APPLICATION NO. 07AA-10063	PROJECT NO. 1004474
PROJECT NAME Lands of Menaul School	
EPC APPLICATION NO. _____	
APPLICANT / AGENT Community Sciences	PHONE NO. 397-0000
ZONE ATLAS PAGE H-15	
(SDP for SUB), (SDP for BP), (FINAL PLATS), (MASTER DEV PLAN), (IR), (AA)	
ONE STOP COMMENT FORM LOG

Subject: Submittal of DRB signature set (Administrative Amendments),
Site Plan for Building Permit, The Villas at Menaul (Menaul
School Condominiums), Applicant KB Home NM Inc.

THE VILLAS AT MENAUL
SITE PLAN AMENDMENTS (SP-BP)
AUGUST, 2007

Project No.	8/21/07
Scale	1/8" = 1'-0"
Sheet No.	1804-07
Project Name	LANDSCAPE PLAN
Sheet No.	L OF 3

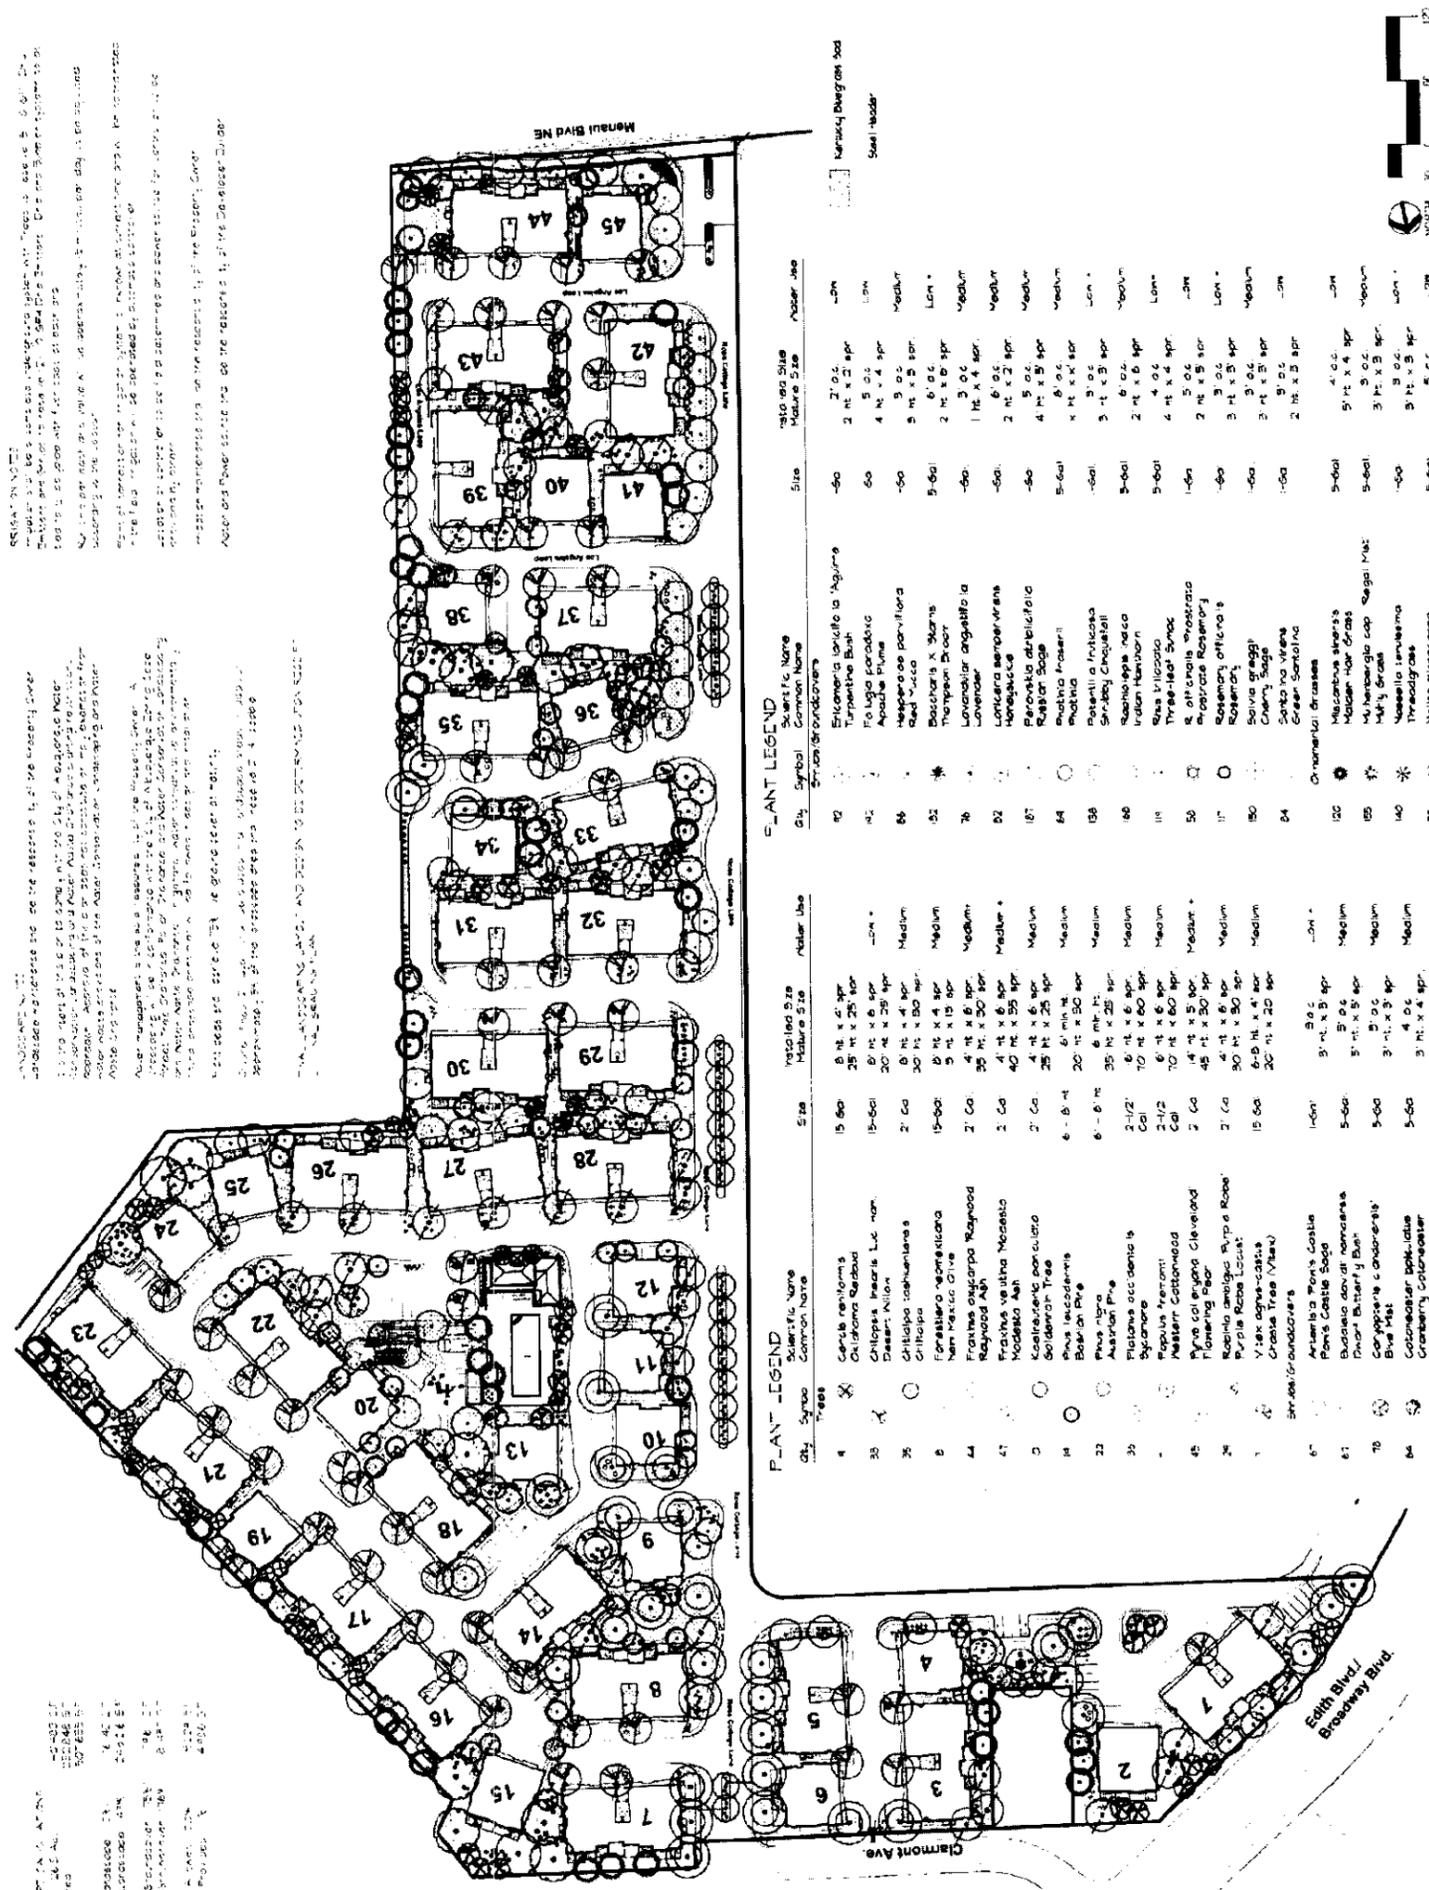
THE PURPOSE OF THIS AMENDMENT IS TO REPLACE THE LANDSCAPING PLAN SHEET
OF PREPARED BY THE HILLTOP LANDSCAPING WITH THOSE BY CONSENSUS
PLANNING INC., THE ASLA OF CONSTRUCTION. THE PLAN IS MODIFIED BY THE
ADDITION OF REAR UNIT PATIOS AND WALLS AND SOME REPLACEMENT PLANT
MATERIALS.

THE VILLAS AT MENAUL
SITE PLAN AMENDMENTS (SP-BP)
AUGUST, 2007

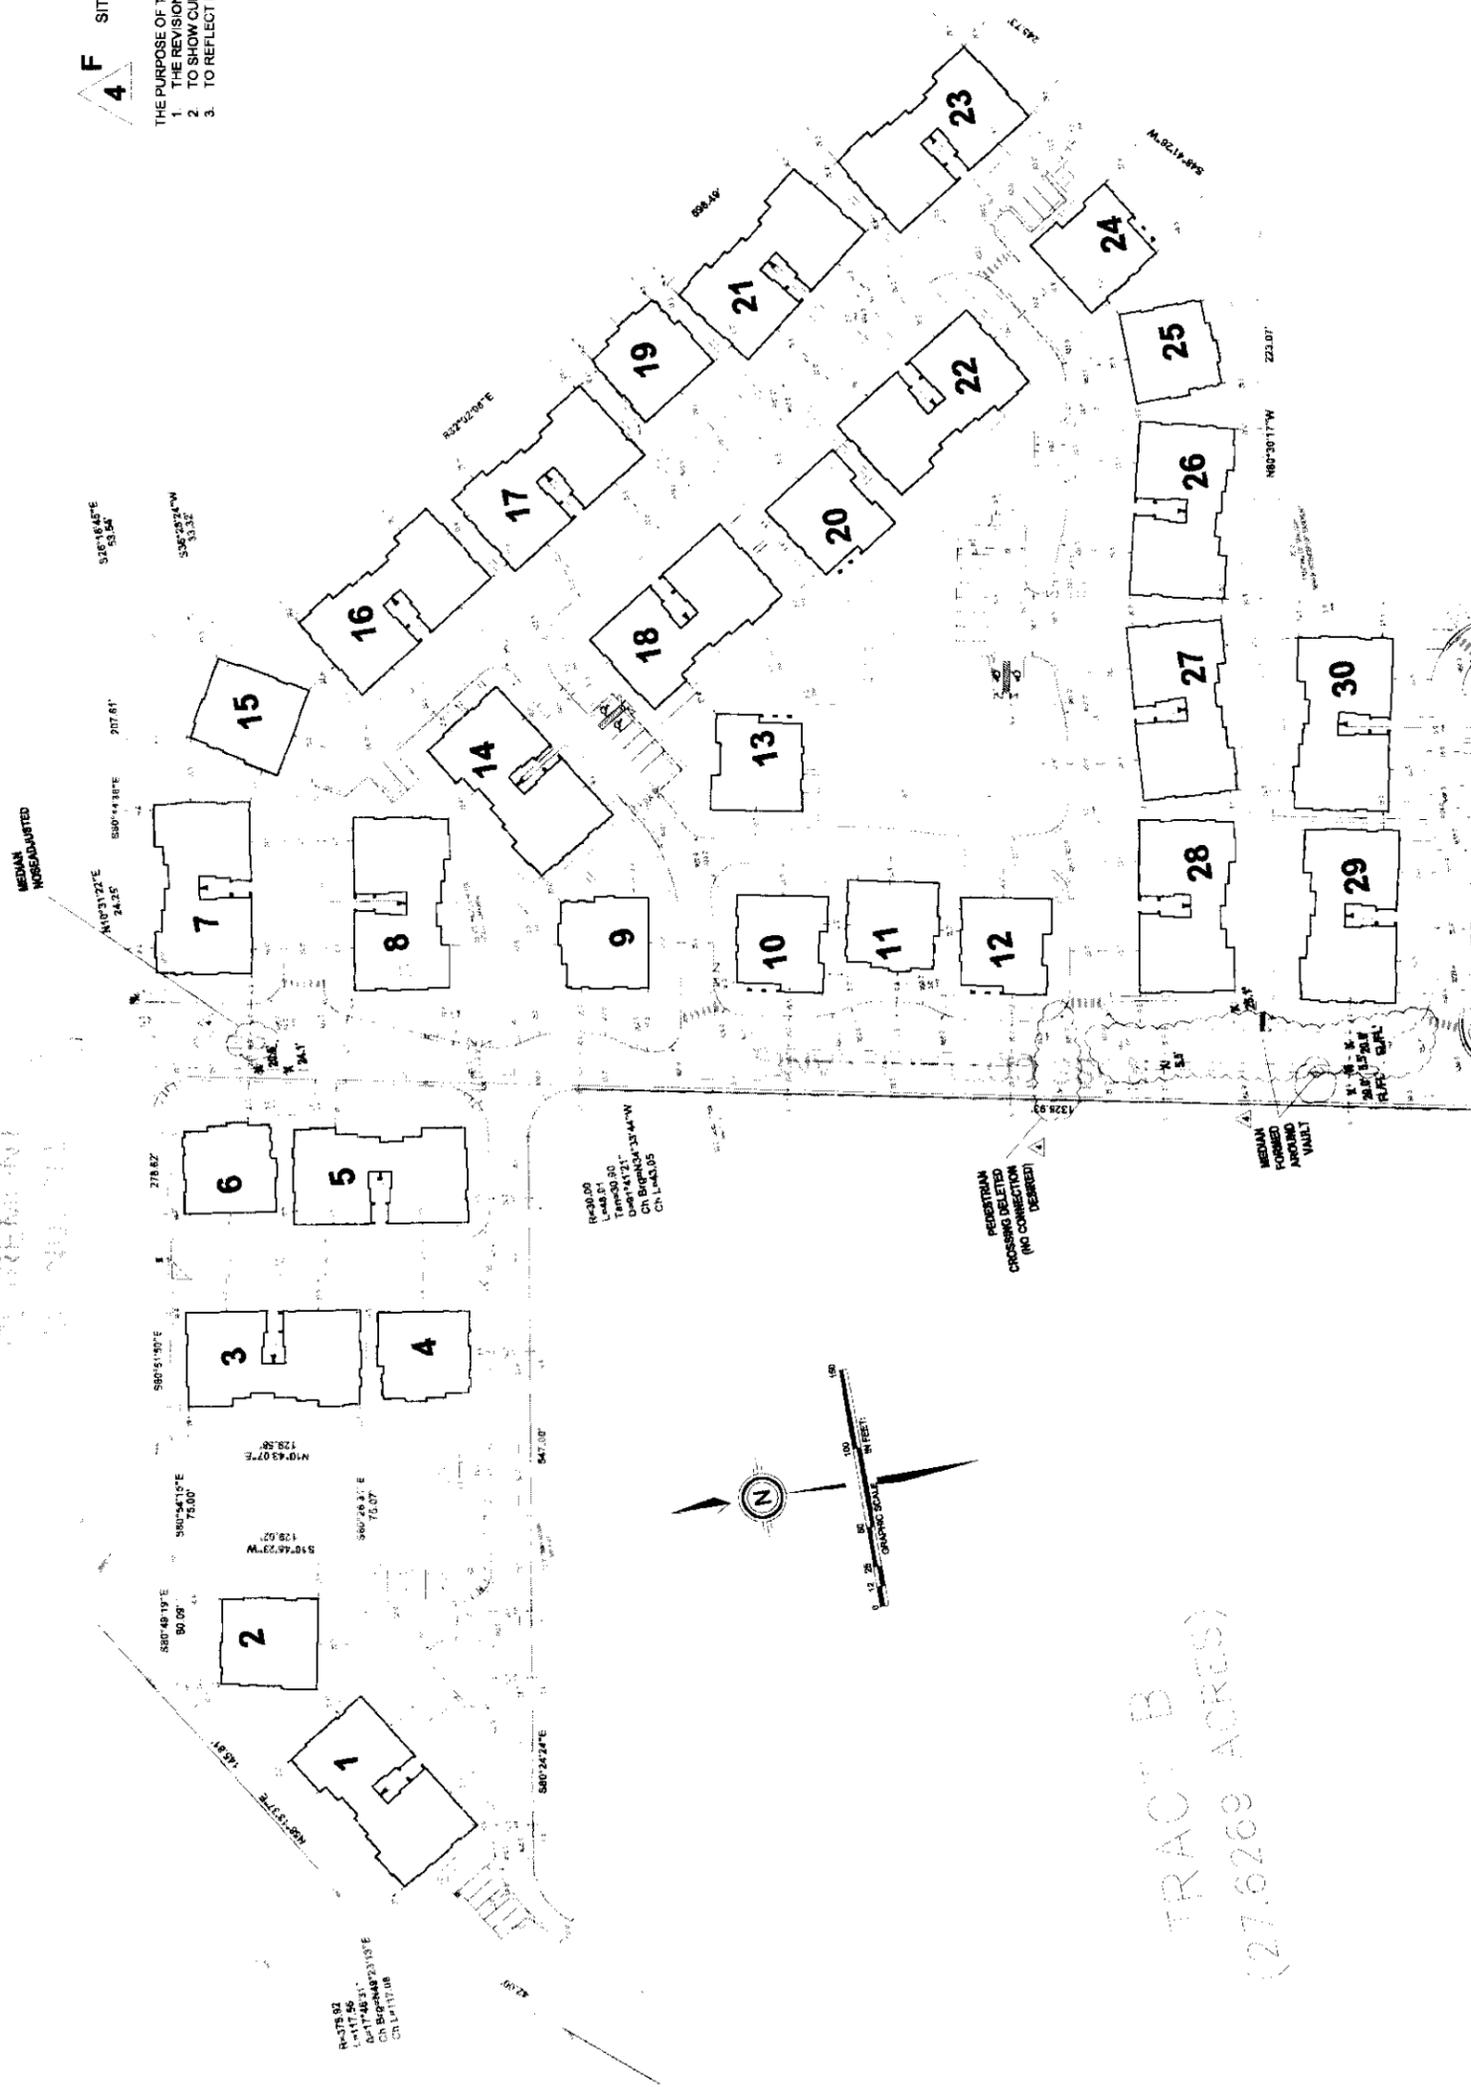
SITE PLAN AMENDMENT AUGUST, 2007:

1. THE REVISIONS TO FULL PATIOS IN THE REAR OF THE UNITS
2. TO SHOW CURBING TAKEN FROM SURVEY AS-BUILTS; AND,
3. TO REFLECT FIELD REVISIONS TO CURBING AND DIMENSIONS WHERE SHOWN.
